SANTA MONICA MOUNTAINS CONSERVANCY

**California High-Speed Rail Authority's Final Environmental
Impact Report/Environmental Impact Statement for the
Palmdale to Burbank Section (SCH 2014071074)**

Recommendations Regarding the Palmdale to Burbank High-Speed Rail Project's Final Environmental Impact Report/Environmental Impact Statement

CA HSR – Bee Canyon to Agua Dulce Canyon
Vicinity Map

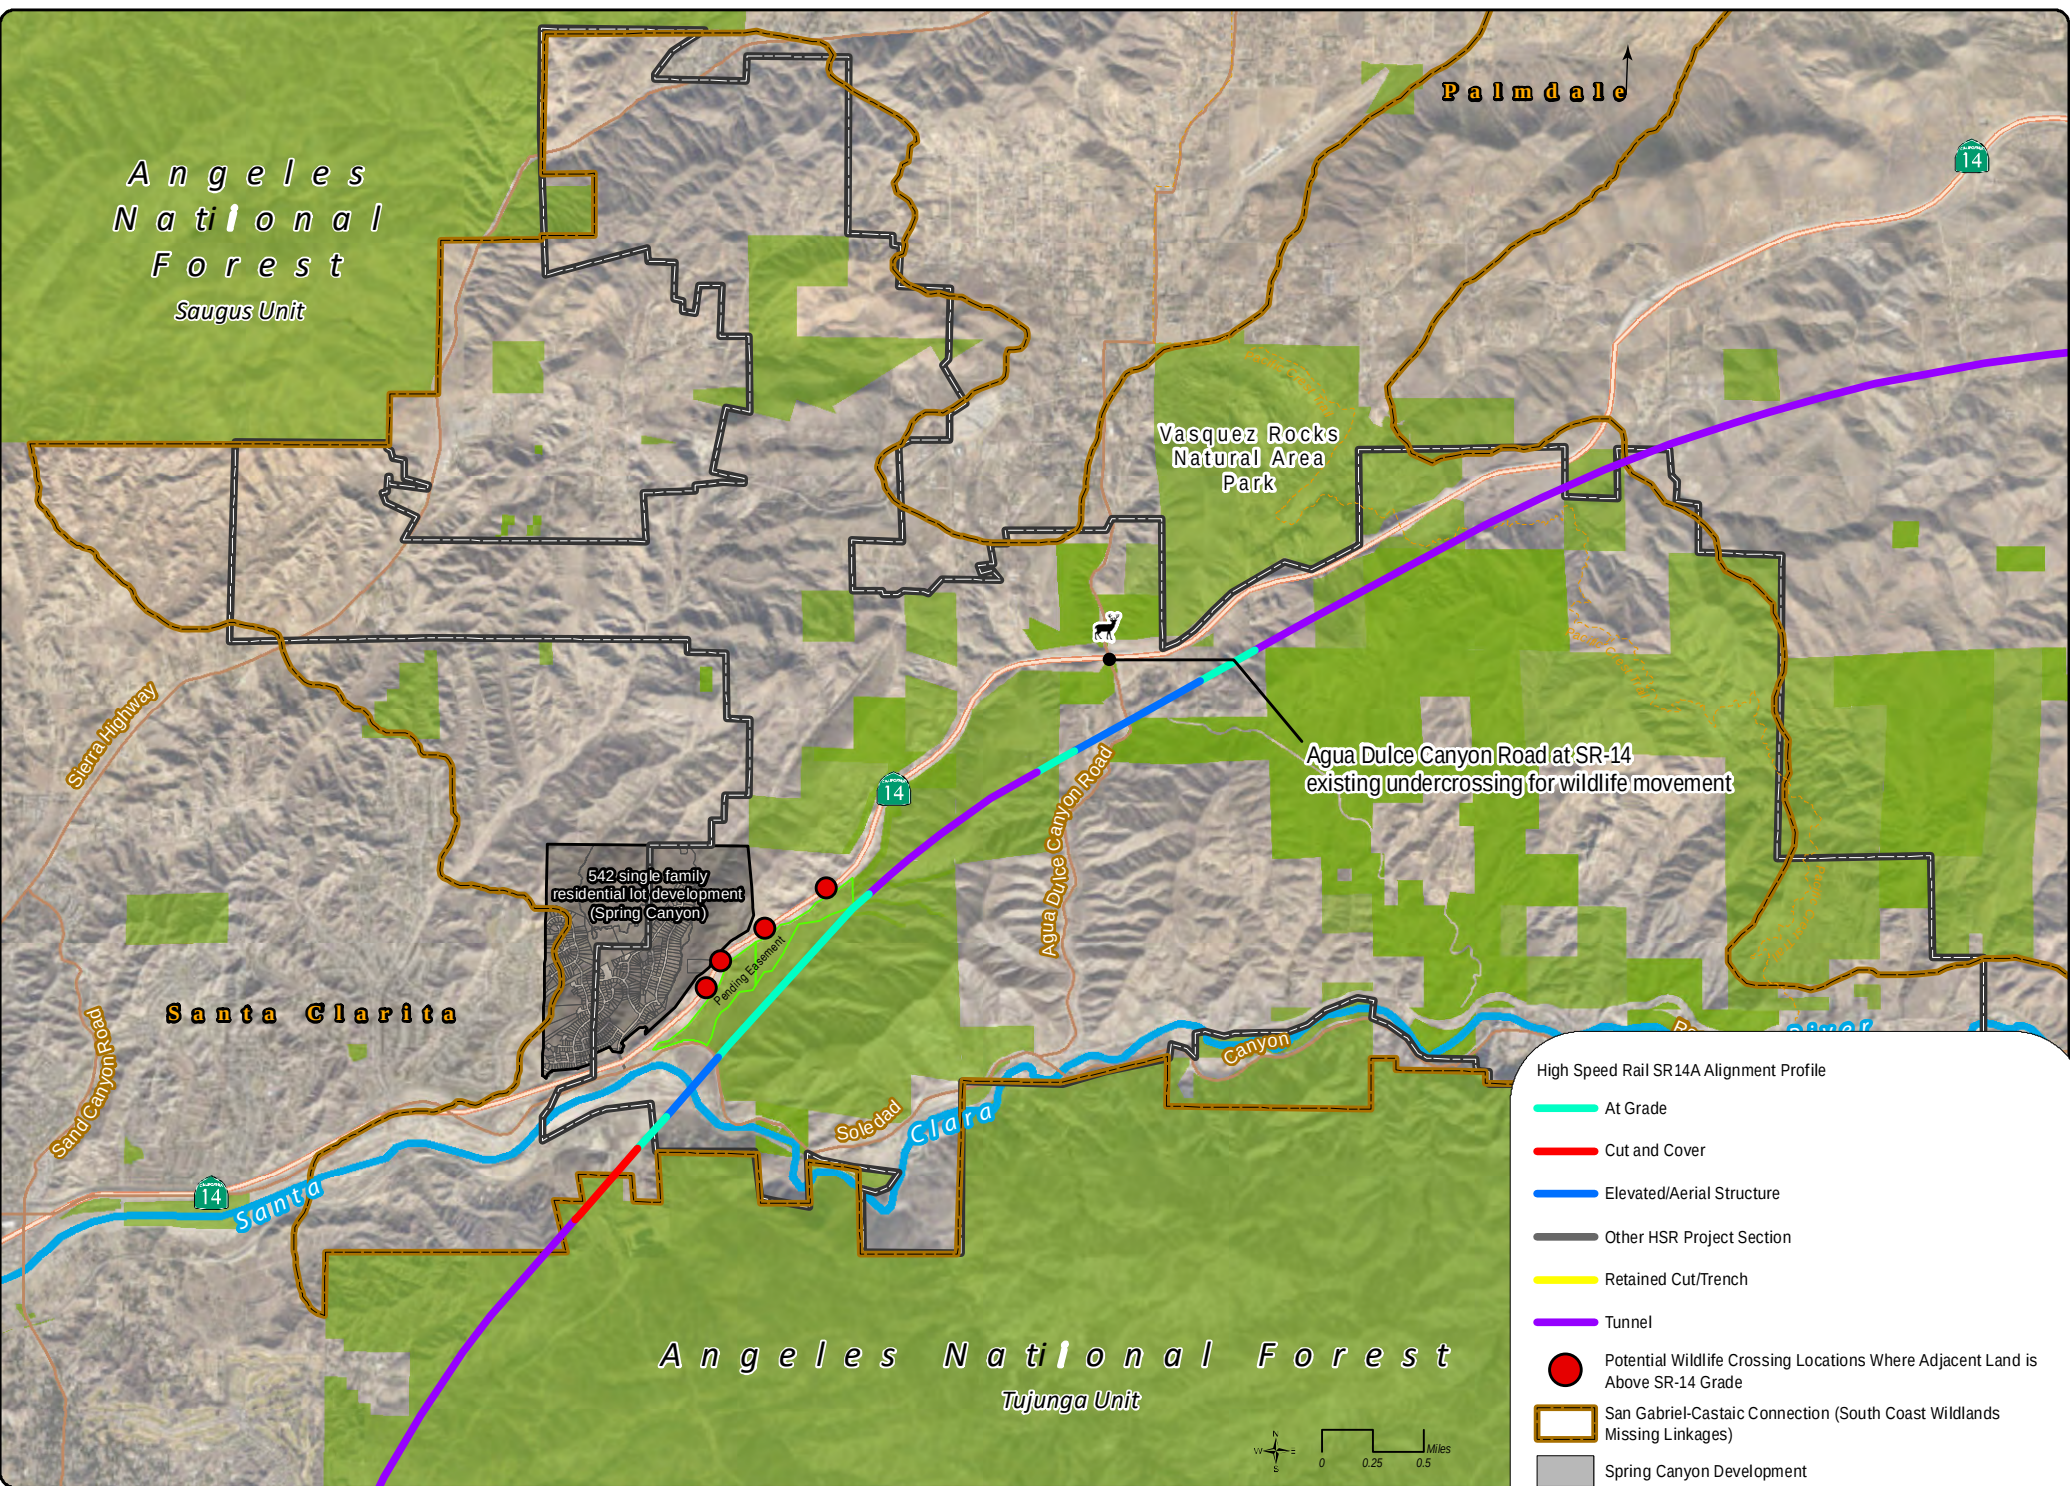
The MRCA's F-EIR/EIS comment letter dated June 5, 2024 identifies four locations between Stonecrest Road and Agua Dulce Canyon Road where a wildlife overcrossing of SR-14 could be accommodated. See attached MRCA map.

MRCA recommends the Authority consult with Caltrans to reach 65-percent design plans including a Project Initiation Document (PID), Project Approval and Environmental Document (PA/ED), and Plans, Specifications and Estimates (PS&E) for one of the four identified locations along SR-14 between Stonecrest Road and Agua Dulce Canyon Road where lands on either side of SR-14 are above grade and would facilitate a wildlife overcrossing less than 175-feet in length and less than 100-feet wide.

CA HSR – Bee Canyon to Agua Dulce Canyon
Area Map

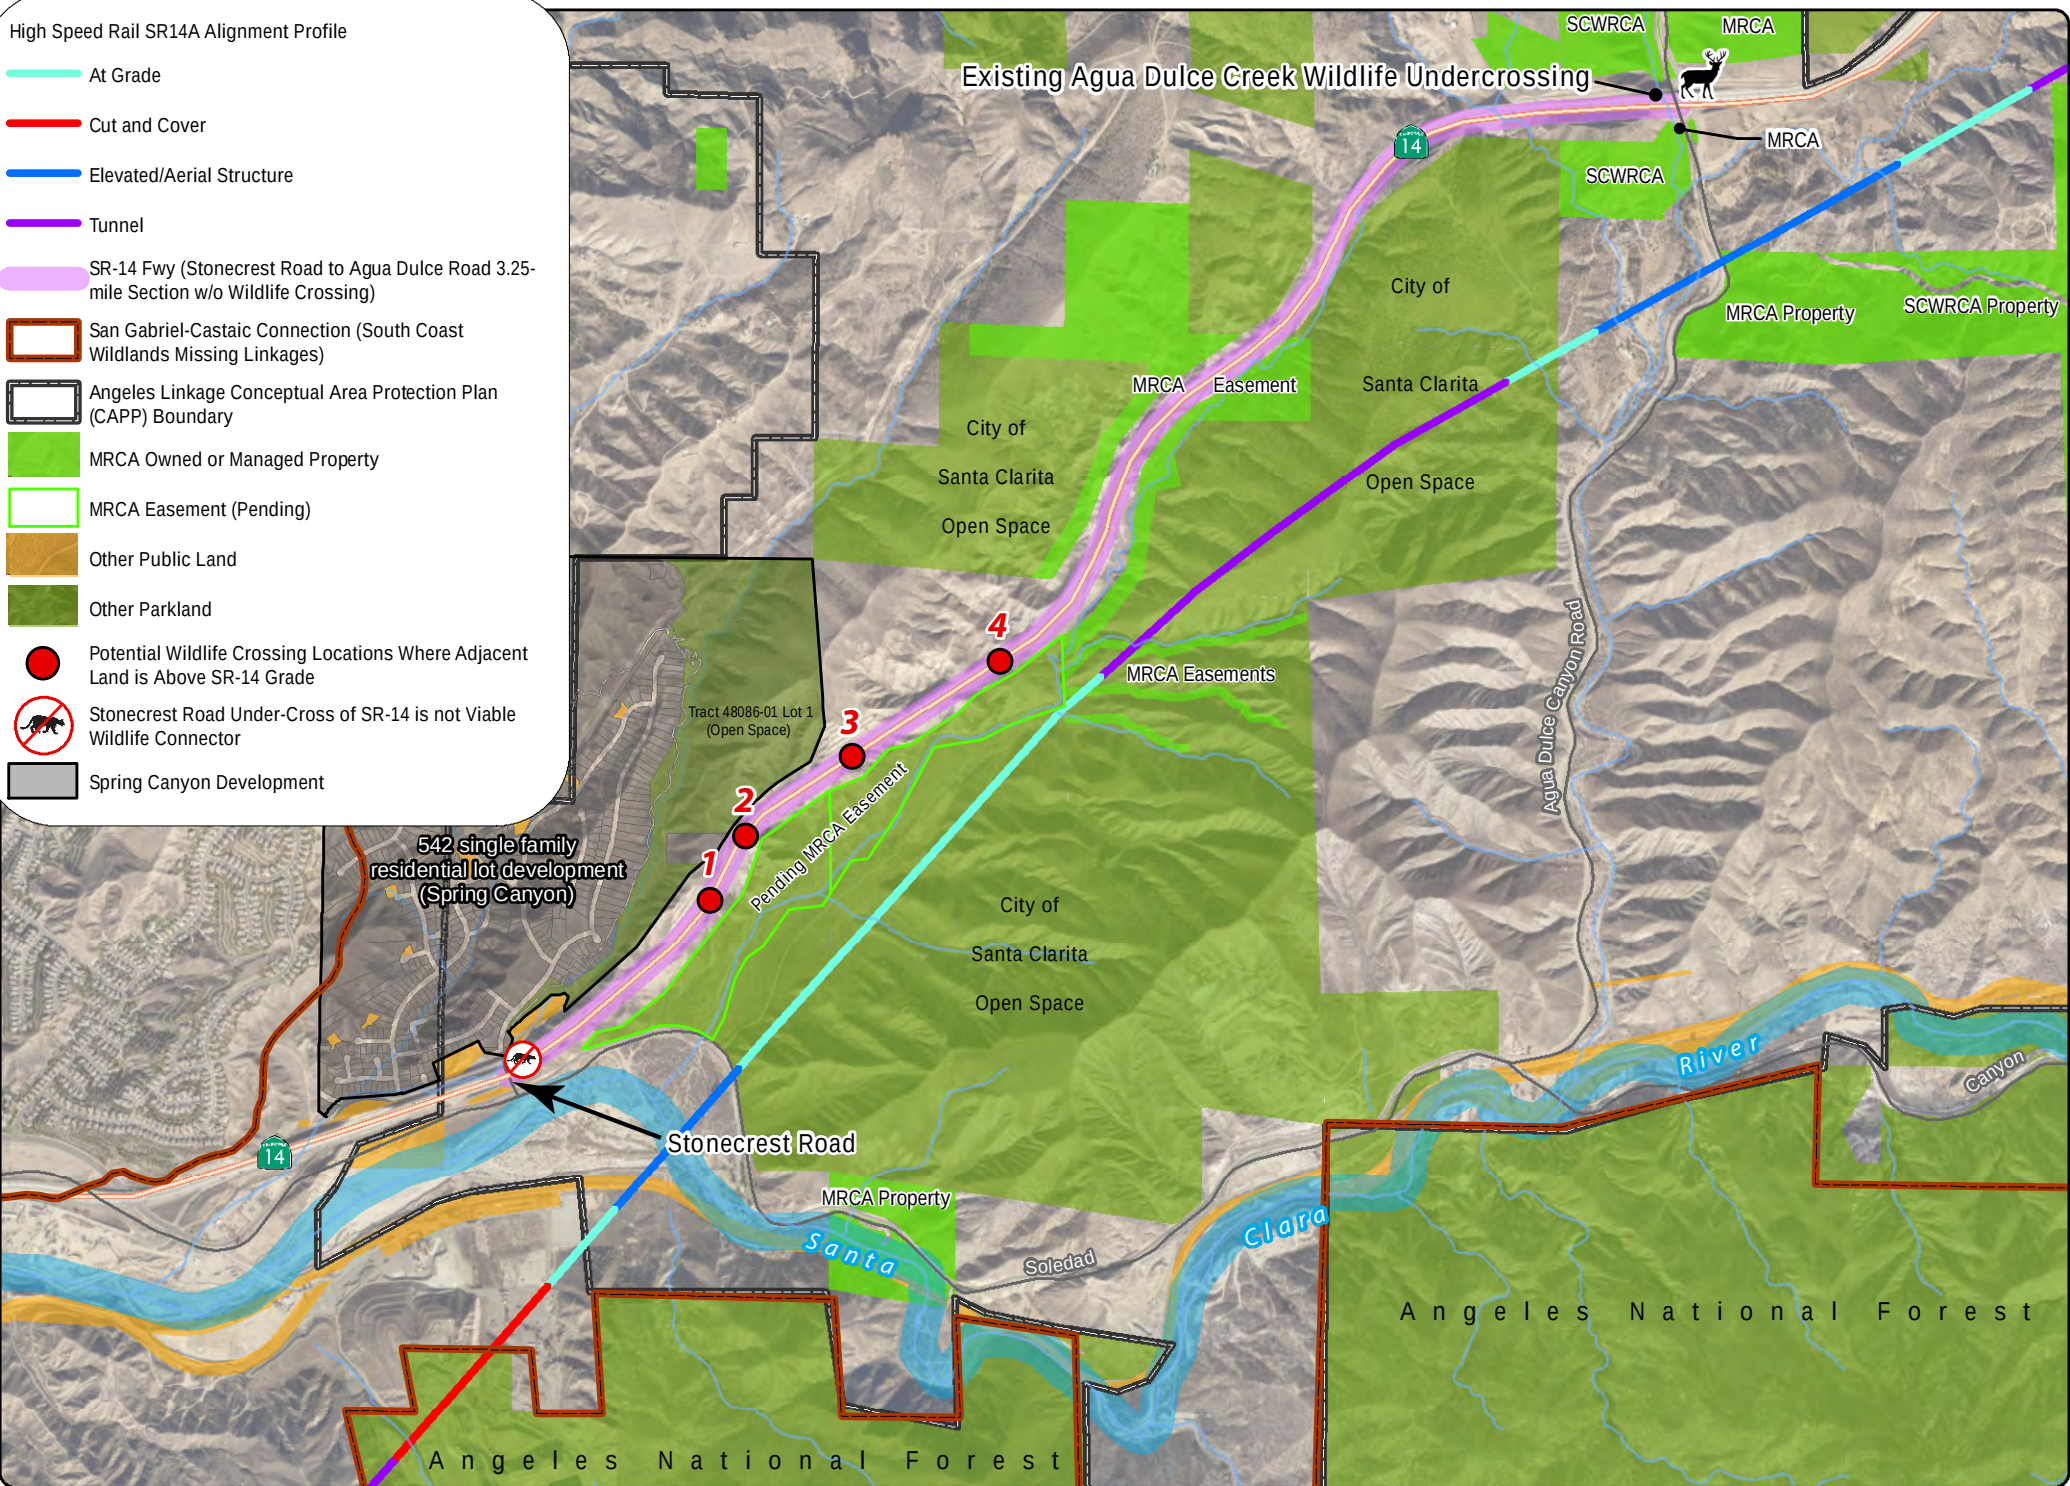
Recommendation No. 1: Contribute to a new SR-14 wildlife crossing structure between Spring and Bee Canyons along the approximate 3.25-mile segment of SR-14 from Stonecrest Road to Agua Dulce Canyon Road.

Stonecrest Road is not a viable, long-term wildlife crossing of SR-14 because it proposed as a primary access point for the development of 542 single family residences in Spring Canyon. Increased traffic, noise, lighting, and trash from the proposed development will deter wildlife utilization of Stonecrest Road. However, if the Authority purchases (all or significant portions of) the proposed tract developments in Spring Canyon opposite SR-14 from Bee Canyon, then Stonecrest Road can become a protected wildlife crossing with additional wildlife fencing and strategic habitat improvements to guide animals safely away from SR-14 and Soledad Canyon Road. The Authority's pursuit of this option would alleviate the need for Recommendation No. 1 above.

CA HSR – Bee Canyon to Agua Dulce Canyon
Public Access Map

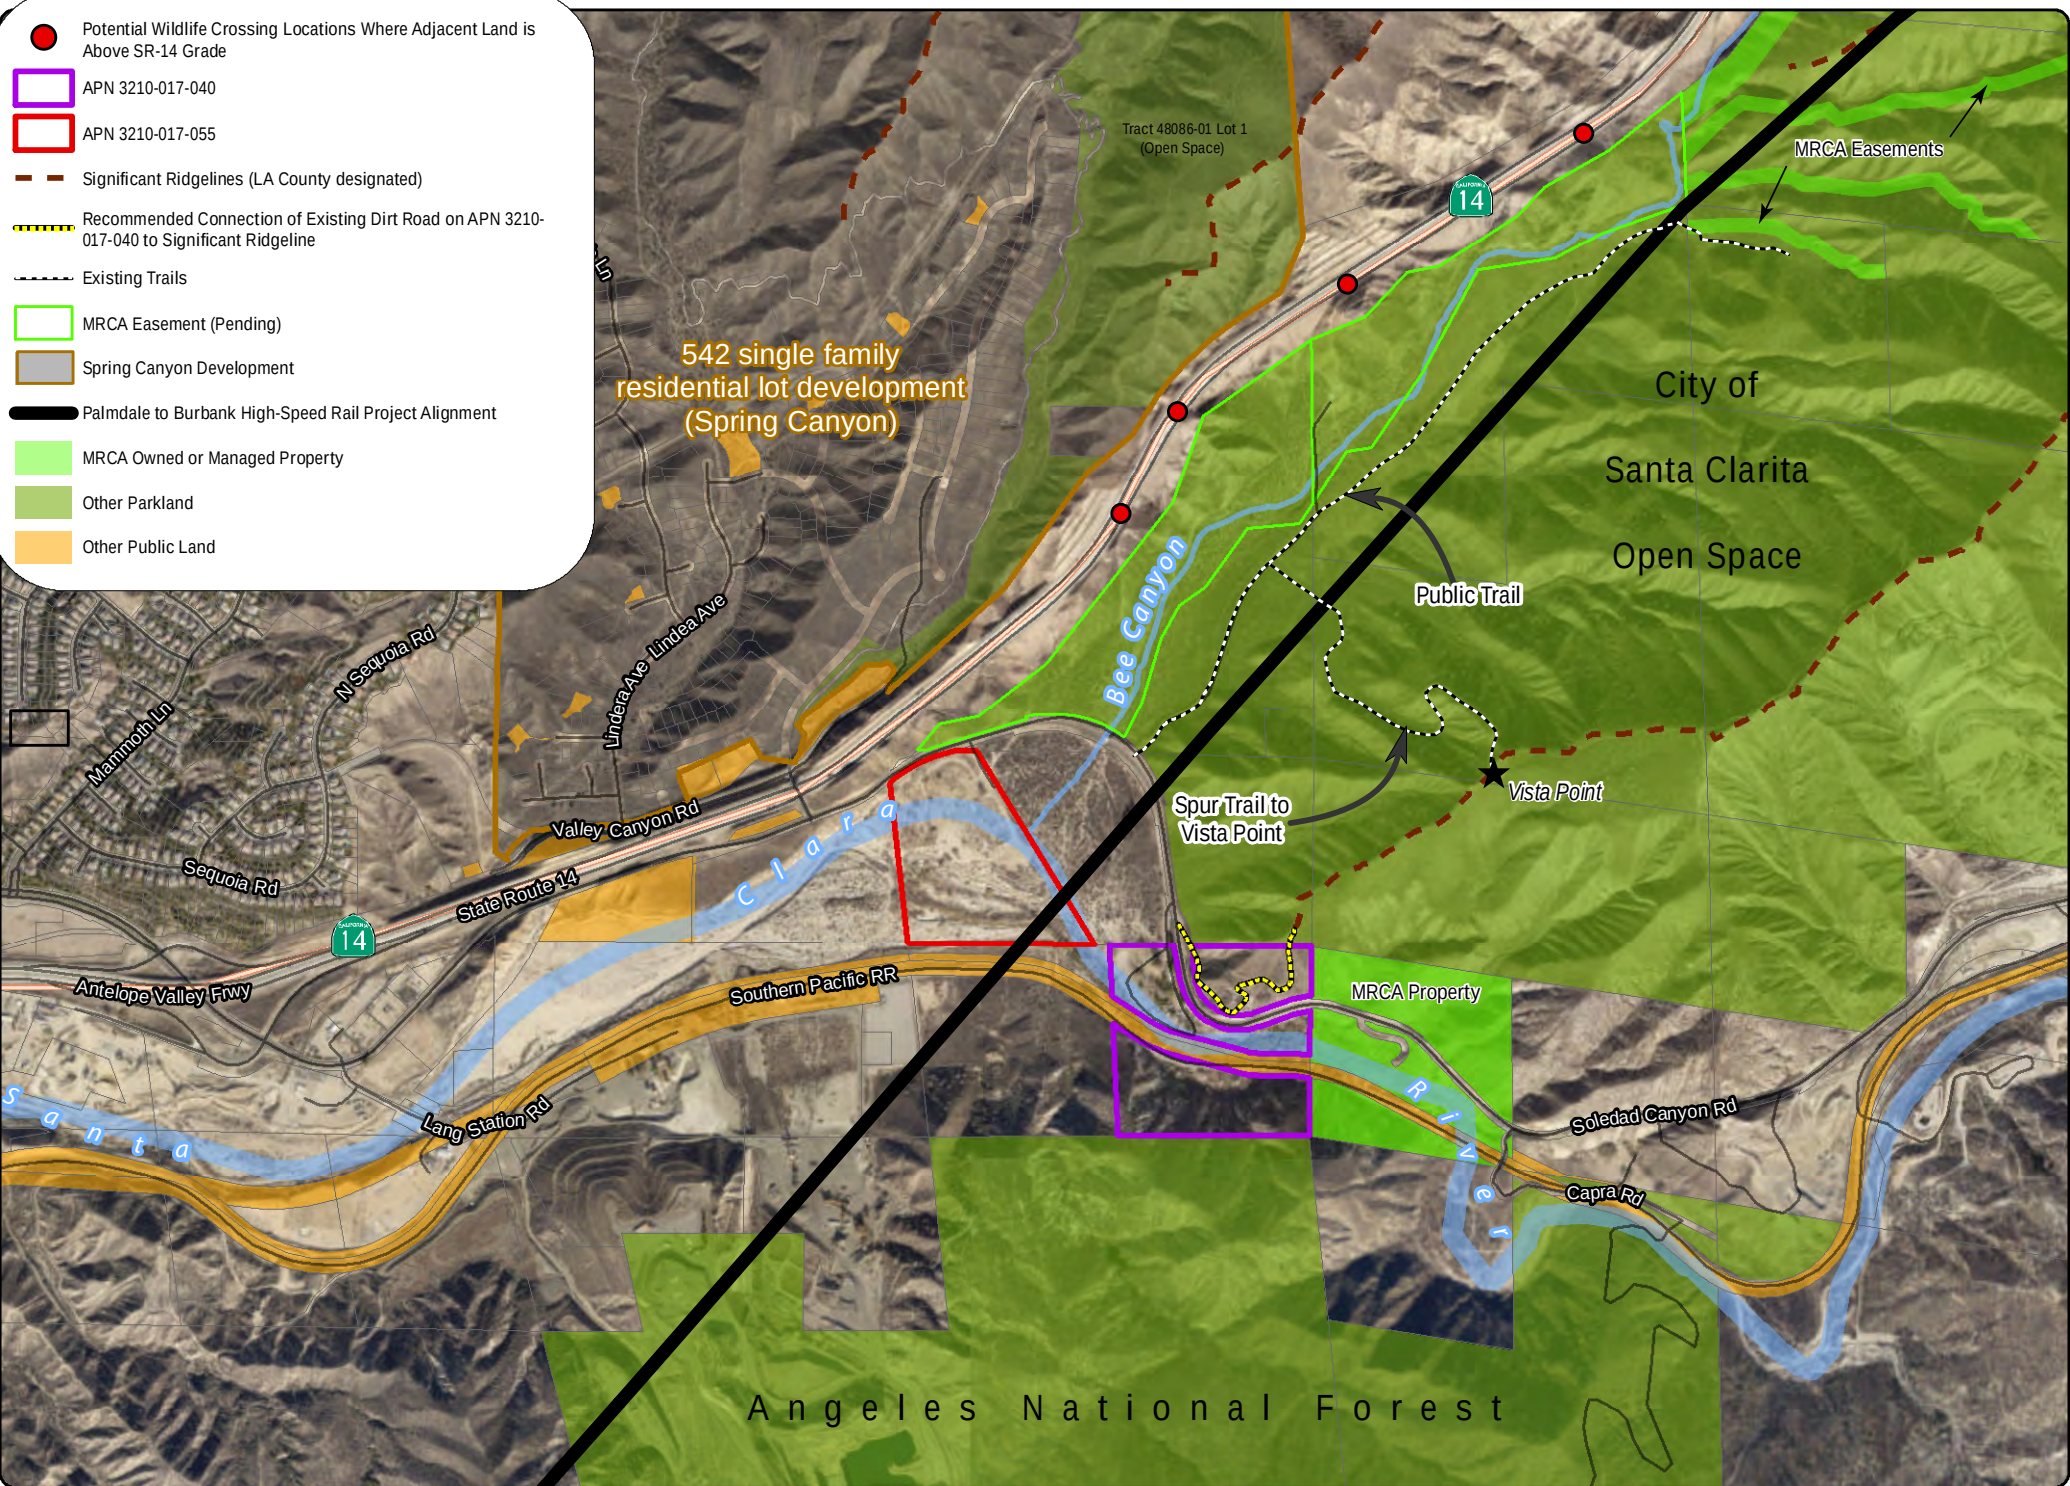
Cursory review of publicly available aerial imagery shows a spur trail and fire road approximately 1,500 feet from the trailhead that travels east across the proposed HSR

route and up to a Los Angeles County-designated Significant Ridgeline with near-360-degree views. This informal trail and fire road then follows the ridge divide northeasterly between Bee Canyon and Soledad Canyon with no other known access points from adjacent public lands. The out-and-back distance from trailhead to promontory lookout is approximately 1.75 mile and MRCA staff have, on multiple occasions, witnessed hikers ascending or descending this lookout trail. The main trail in Bee Canyon is near the canyon bottom and does not provide the same opportunities for expansive views.

Therefore, MRCA recommends the Authority purchase additional lands on the opposite side of Soledad Canyon Road, specifically APN 3210-017-055 that has had historical development and could easily accommodate public parking, ADA-accessible restroom(s), and a trailhead to serve Lang Station Open Space at Bee Canyon trails. This same property will support footings for the HSR bridge over the Santa Clara River and could be used as a temporary HSR construction staging yard to minimize impacts within Bee Canyon.

To maintain fire safety in this CalFire-designated Very High Fire Hazard Severity Zone, MRCA also recommends the Authority connect an existing dirt road on APN 3210-017-040 to the above-mentioned ridgeline fire road. This will allow fire agencies to maintain access to this high fire frequency area and provide public recreation connection to eastern portions of Lang Station Open Space at Bee Canyon.
